DEVELOPMENT ASSESSMENT PANEL REPORT

Application No.	MOD/2024/0079
Address	86 Rowntree Street BIRCHGROVE
Proposal	Section 4.55(2) modification of Determination No DA/2020/0771 which approved alterations and additions to the existing dwelling. House. Modification seeks internal and external changes.
Date of Lodgement	18 March 2024
Applicant	Mr Leonard V Hambleton
Owner	Mr Leonard V Hambleton Ms Rhian N Czech
Number of Submissions	Initial: Zero (0)
Cost of works	Initial: \$150,000.00 Proposed: \$700,000.00
Reason for determination at Planning Panel	Departure from development standards
Main Issues	<ul style="list-style-type: none"> • Departure from the Floor Space Ratio development standard, which surpasses the previously approved level of non-compliance. • Departure from the Landscaped Area development standard, which is a further reduction from the previously approved level of Landscaped Area. • Proposed private open space deviates further from the minimum quantitative requirements at Part C3.8 of the Leichhardt Development Control Plan 2013.

Photo 1: Photo taken from rear of property looking south

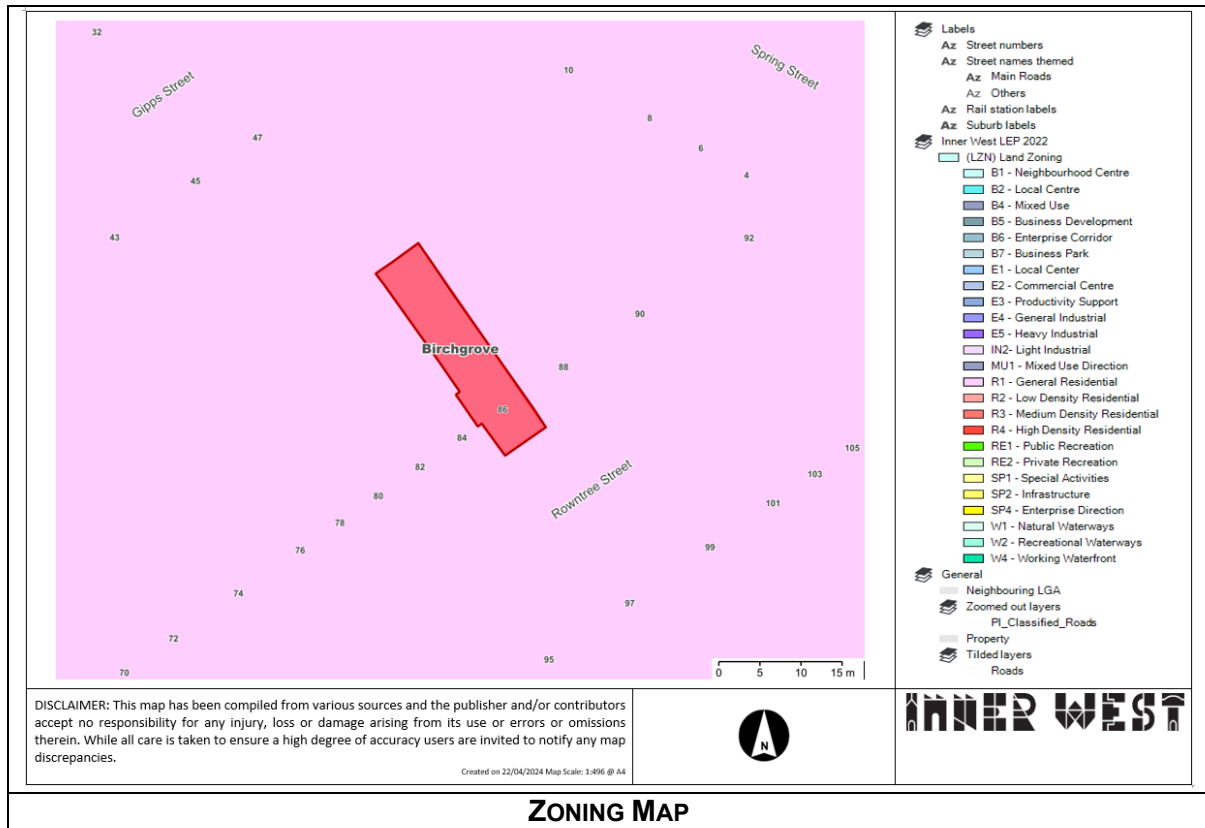
The Site is currently a construction site and various elements of the existing building have already been demolished (see photos below).

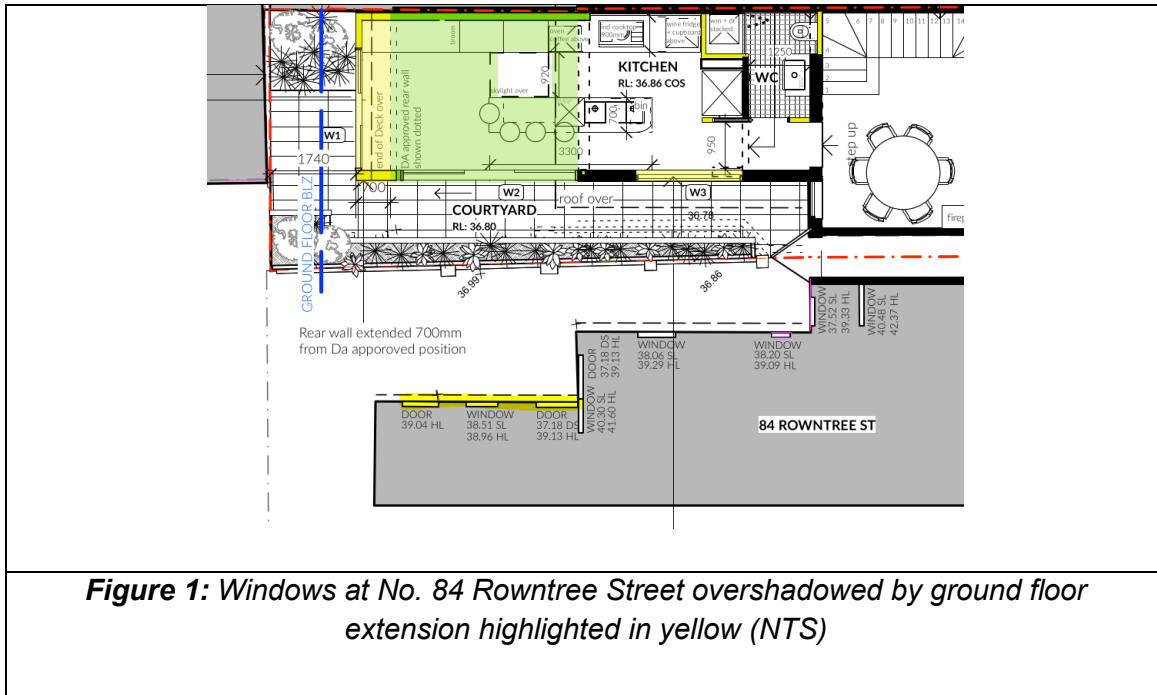
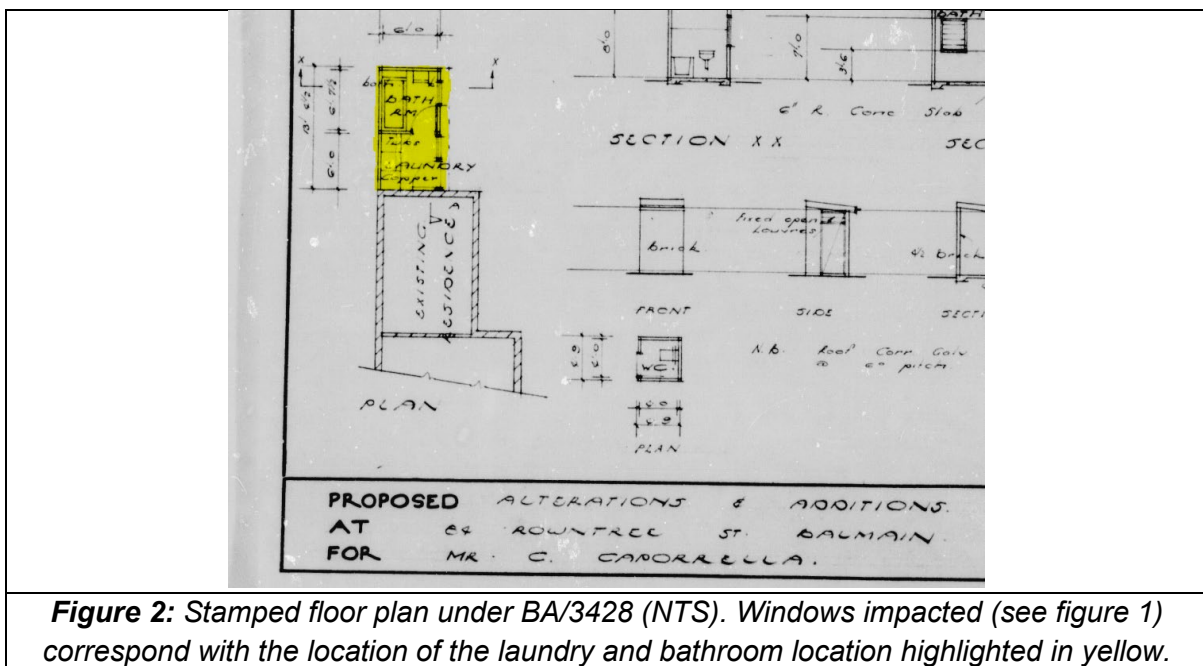
The proposed ground floor extension would cause additional overshadowing to side facing openings at No. 84 between 9am and 12pm, the windows impacted by the ground floor extension are highlighted in yellow in figure 1 below:

As desktop review of Council’s records indicates under BA/3428 that these openings do not serve the main living area and serve a laundry and bathroom (see image below).

Having regard to the use of these rooms, which are not protected under Part C3.9 of the LDCP 2013, overshadowing to these openings is considered acceptable.

Figure 3: Openings at No. 84 Rowntree Street overshadowed by ground floor extension highlighted in yellow (NTS)

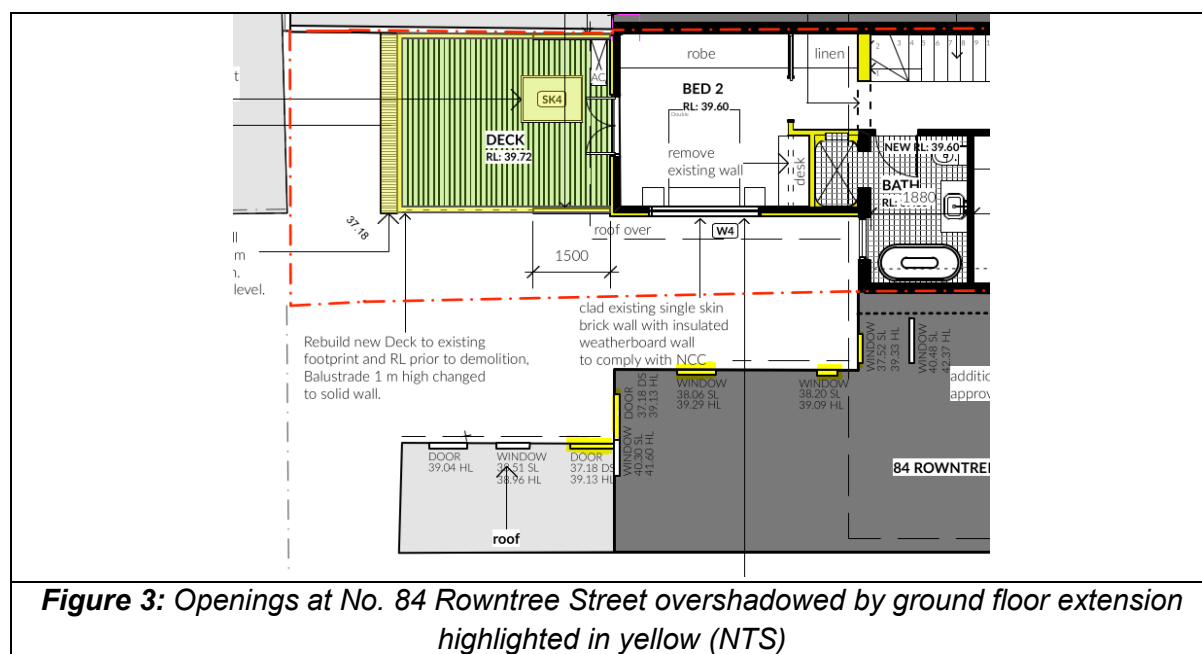
The proposal seeks to install a 1800mm tall privacy screen, extending 1500mm along part of the western side of the first floor deck. This screen, rising 800mm above the existing 1000mm high balustrade, would cast further shadows on the following windows highlighted in yellow in figure 3 below.

A detailed floor plan of No. 84 Rowntree Street could not be accessed, and no submission was received from the neighbouring property during the notification process, specifying the use of the rooms with windows affected. Notwithstanding, as noted in the LDCP 2013, assessment of the impact of development on the solar access of neighbouring properties considers the following matters, which are derived from the Planning Principle established in *The Benevolent Society v Waverley Council* [2010] NSWLEC 1082:
